# CONSTRUCTION DRAWINGS FOR STONEBRIDGE FILING 4 AT MERIDIAN RANCH

## IMPROVEMENT PLANS

PREPARED FOR **GTL, INC. DBA GTL DEVELOPMENT, INC.**

MERIDIAN HILLS TR.  
CUL-DE-SAC  
(ALL GRADES ARE TBC)

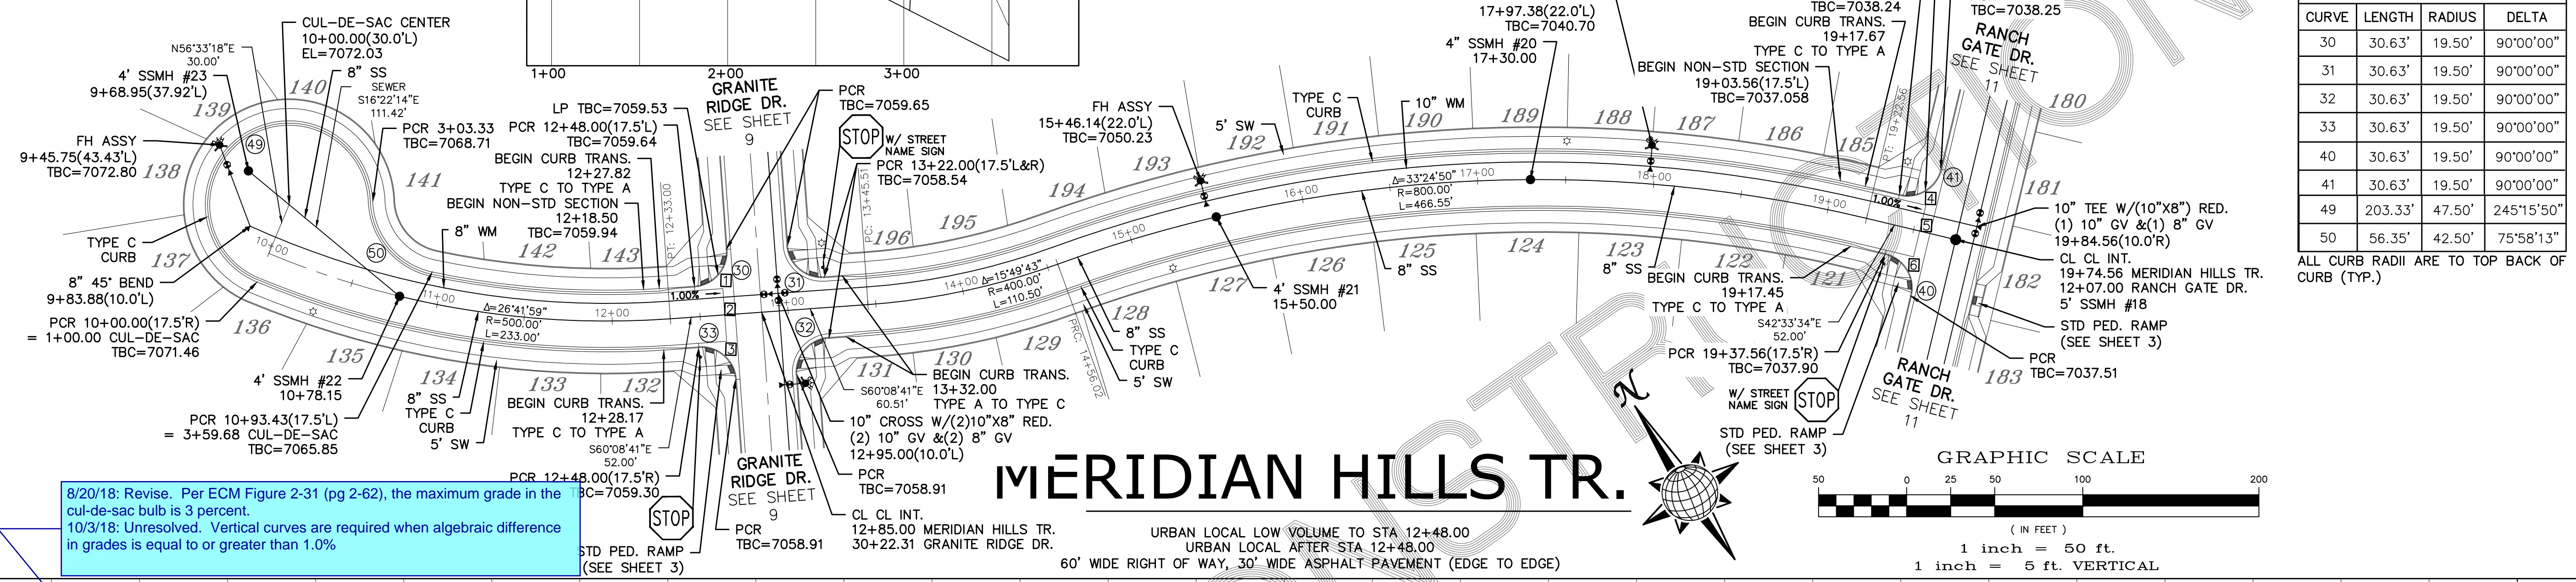
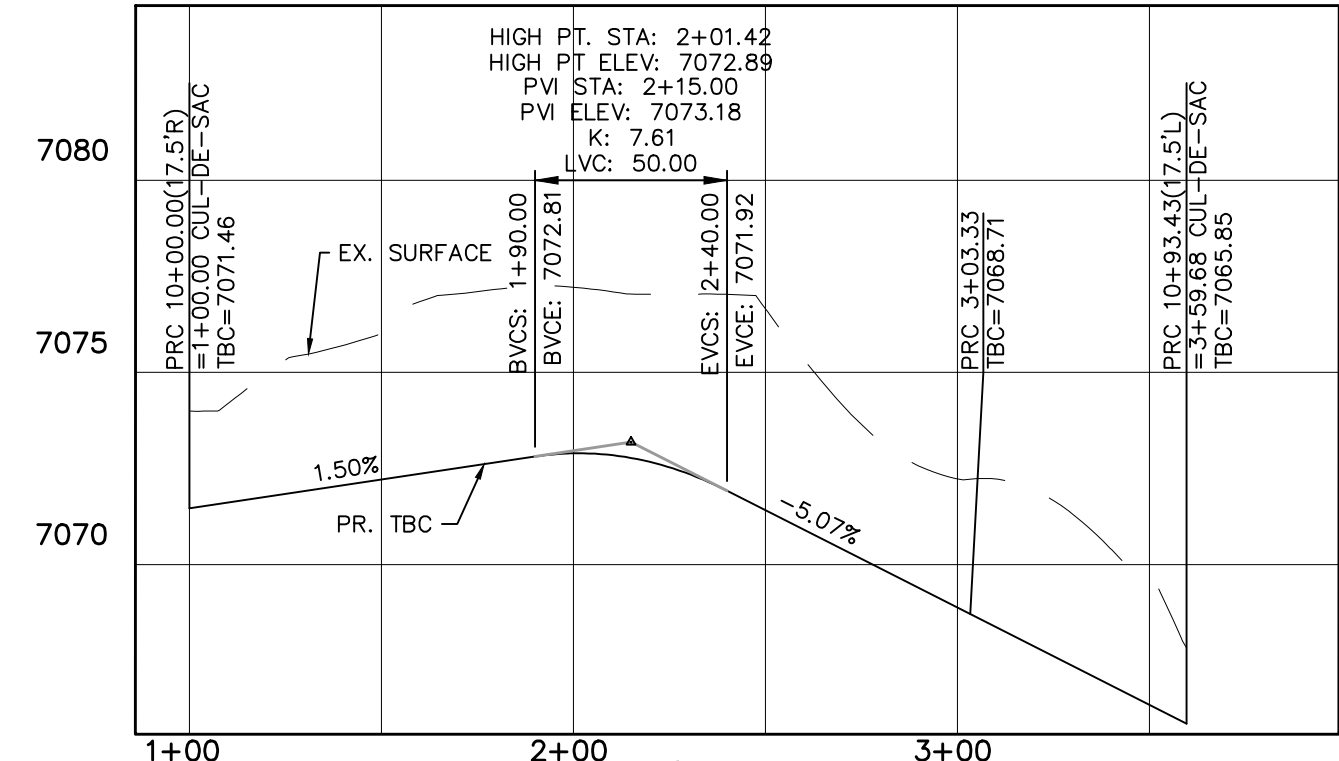
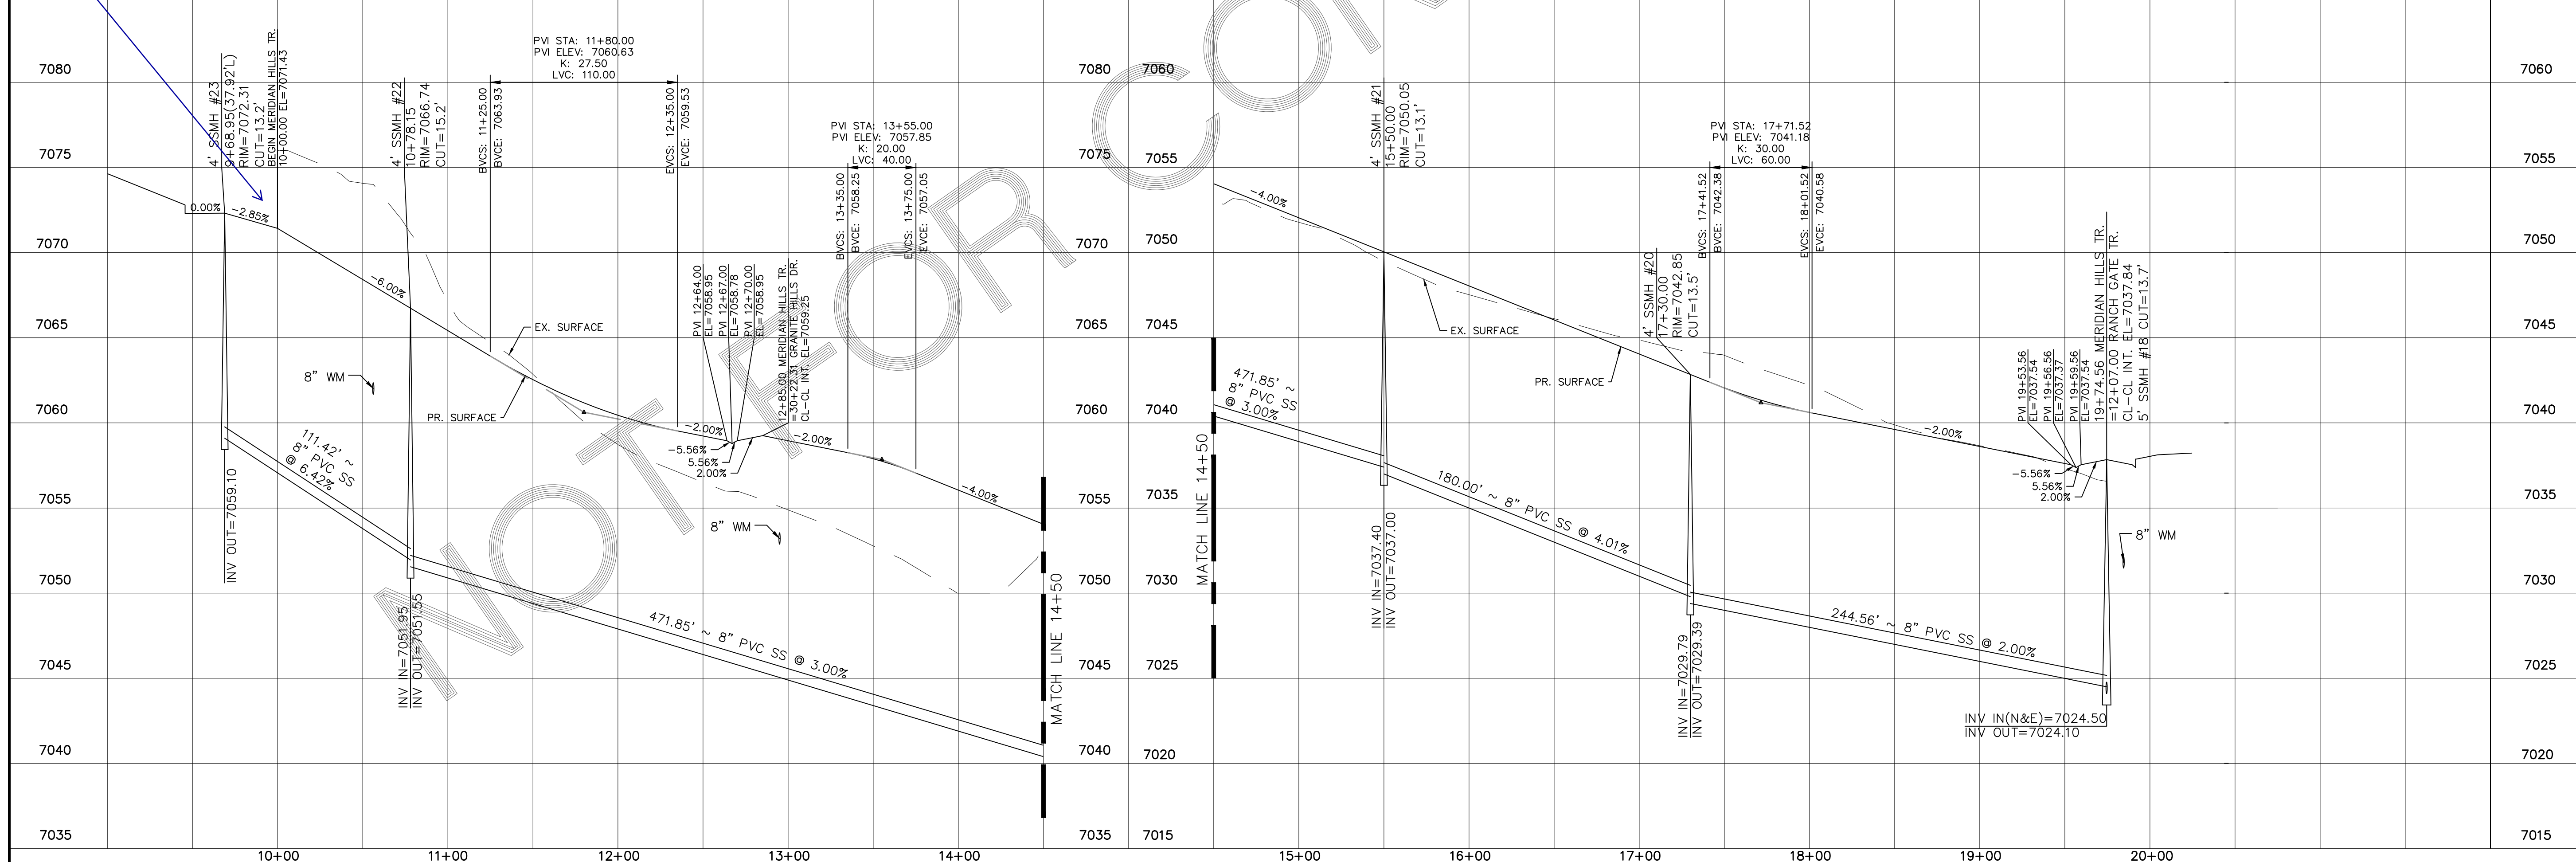
8/20/18: Revise. Per ECM Figure 2-31 (pg 2-62), the maximum grade in the cul-de-sac bulb is 3 percent.  
10/3/18: Unresolved. Vertical curves are required when algebraic difference in grades is equal to or greater than 1.0%
